STAFF REPORT: APPEAL *DE NOVO*

Appeal No.: **A-1-MEN-10-015**

Applicants: **Barbara Bethel and James Hupp**

Location: Approximately 1.5 miles south of the Town of Mendocino, on the east side of Frontage Road 500B (County Road #500B), approximately 50 feet southeast of its intersection with Highway One at 9401 Brewery Gulch Road (Road 500B), Mendocino (Mendocino County), APN 119-320-04

EXHIBIT NO 10
 APPEAL NO.
 A-1-MEN-10-015
 (Bethel & Hupp)
 Landscaping Proposals &
 Visual Simulations of
 Vegetation Screening From
 Agent (1 of 4)

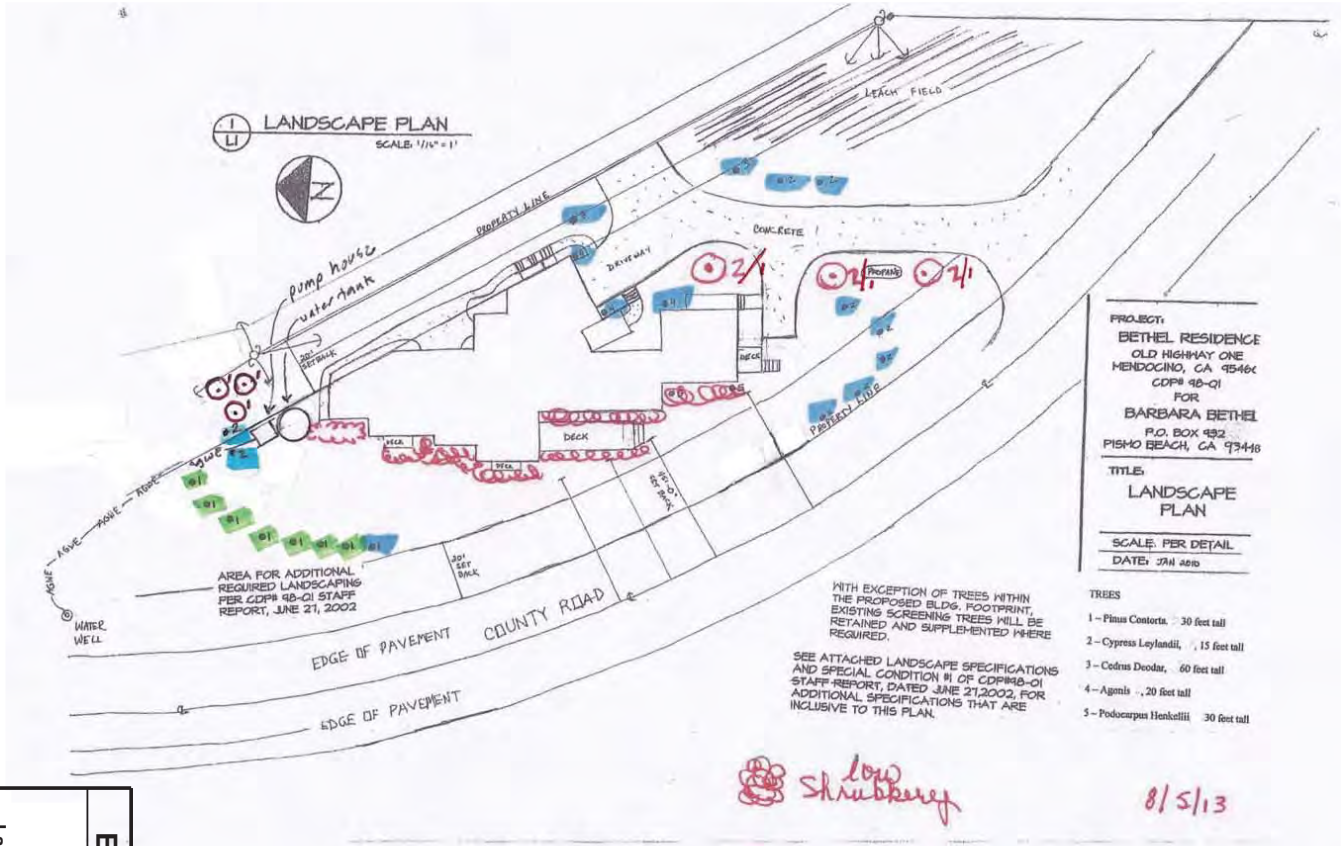
- i. At least thirteen (13) trees shall be planted in a natural, non-linear configuration extending northwest-west of the residence on the parcel in the locations and with a density of plantings as generally shown in green, blue, and red colors on the annotated landscape plan with a handwritten date of August 5, 2013, titled "Landscape Plan, proposed modification," and submitted to the Commission staff on August 19, 2013 (page 1 of **Exhibit 10**);

- iii. At least three (3) trees shall be planted west of the driveway as generally shown and labeled "Additional Trees, 2013" on the annotated landscape plan with a

handwritten date of August 5, 2013, titled “Landscape Plan, proposed modification,” and included as page 1 of **Exhibit 10**;

- iv. Shrubs shall be planted to form a continuous screen along the west and northern facades, with a minimum height at maturity of 3 feet, and as generally shown and labeled “low shrubbery” on the annotated landscape plan with a handwritten date of August 5, 2013, titled “Landscape Plan, proposed modification,” and included as page 1 of **Exhibit 10**; and

Exhibit 1: CDPM #98-01(05) Staff
Report Exhibit C - Floor Plan

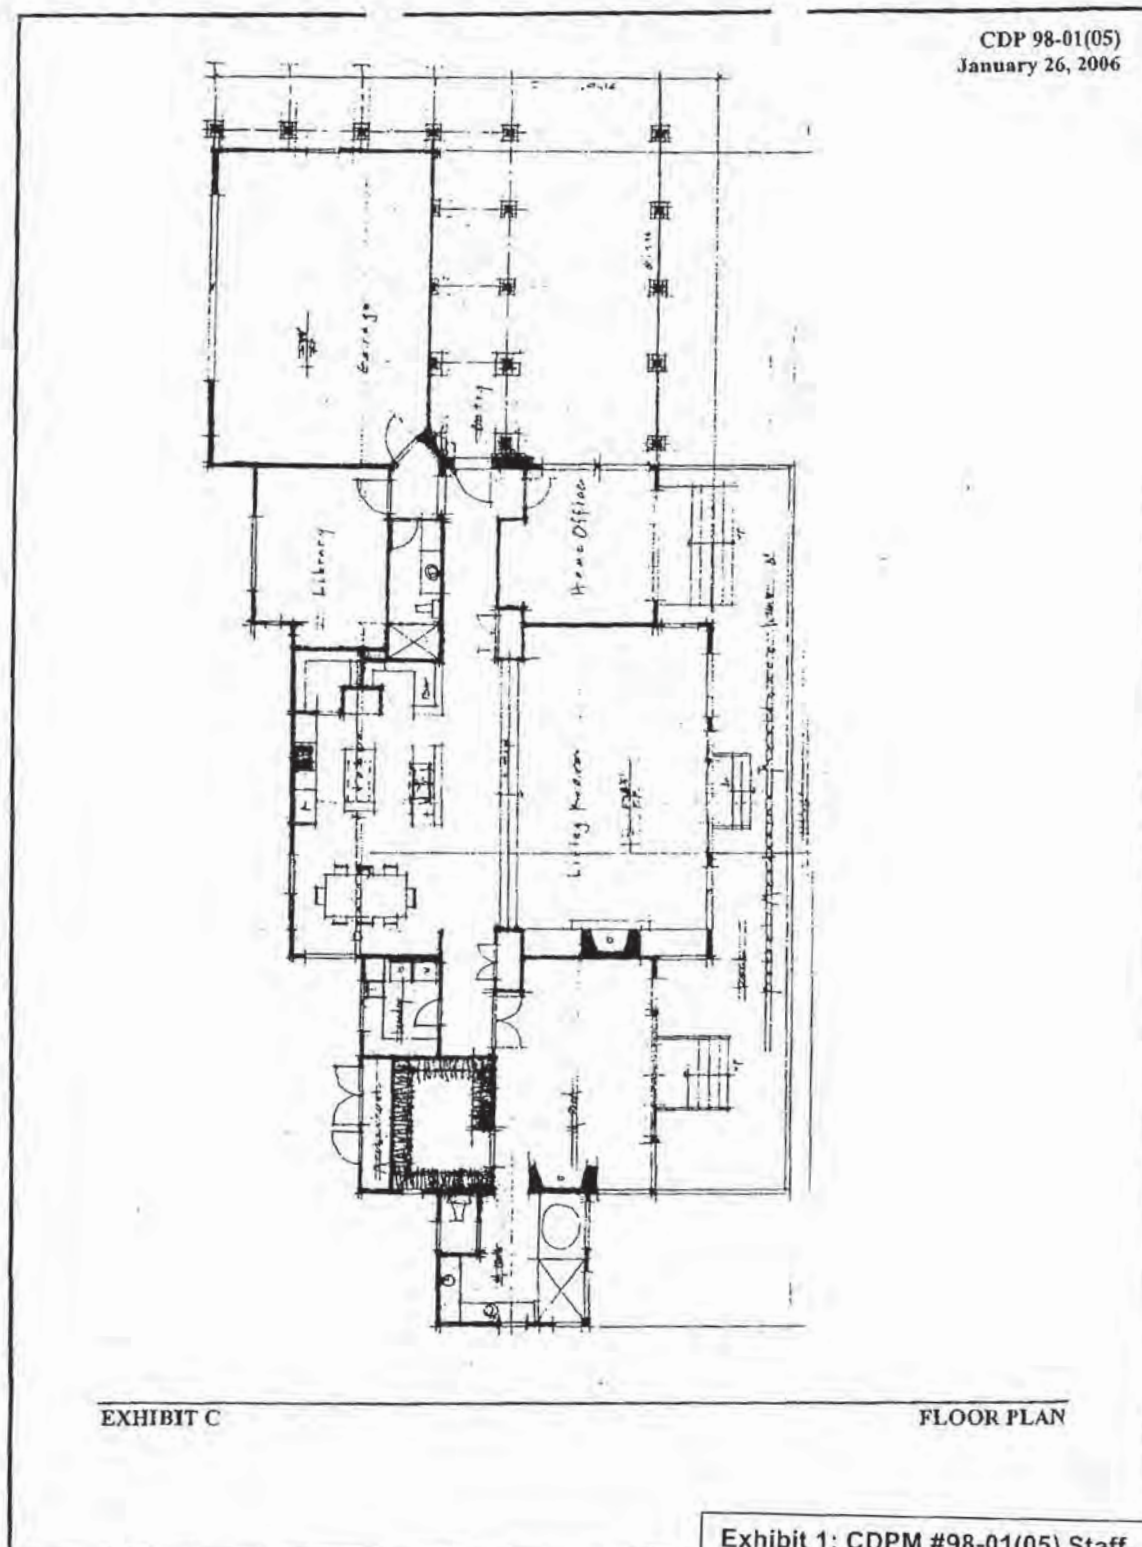
In particular, Abbey discovered that Staff Report Exhibit C – Floor Plan – (see this letter's **Exhibit 1**) does not match Staff Report Exhibit B – Site Plan – (see this letter's **Exhibit 2**) relative to the Entry Courtyard into the residence. This is because Planning Staff mistakenly neglected to replace Staff Report Exhibit C with the Project Team's revised Floor Plan for the residence.

According to the Project Architect of the time, Leonard Grant, there was never any intent to remove the courtyard glazing (noted as "Glass" on the Staff Report's Exhibit C; **Exhibit 1**). Per Mr. Grant's July 9, 2012 letter (original enclosed; **Exhibit 5**),
